PRAIRIE ISLAND NUCLEAR GENERATING PLANT
Docket Nos. 50-282 License Nos. DPR-42
Docket Nos. 50-306 License Nos. DPR-60

Prairie Island Emergency Plan
Implementing Procedures - F3

TEMPORARY CHANGE NOTICE
(SAWI 1.5.10)

Title: Classification of Emergencies

(EAL Ref Manual 11A)

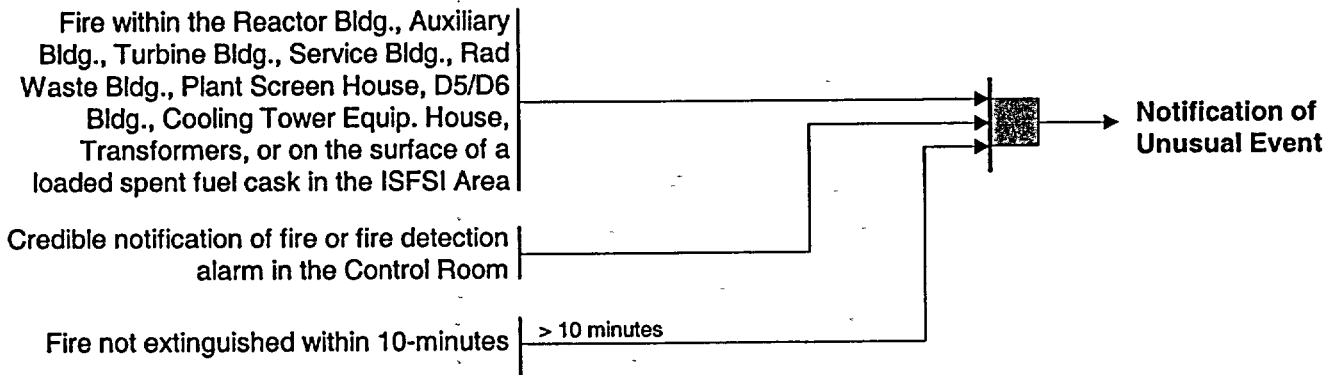
- (e.g page #, step #, summary/reason) (1) Page 36, EAL 11A, to be consistent with NUREG 0654 by 7/14/02
- (2) Page 56, EAL 19G, Added (ITIS, Mode 3, Hot Standby) refer to Nudes 3, 4, 5
- (3) Page 59, EAL 20A, deleted pass through EAL topic.
- (4) Page 56, EA-11 19H, Modified to meet ITIS Standbys by adding Nudes

Fire within the plant or ISFSI lasting more than 10 minutes.
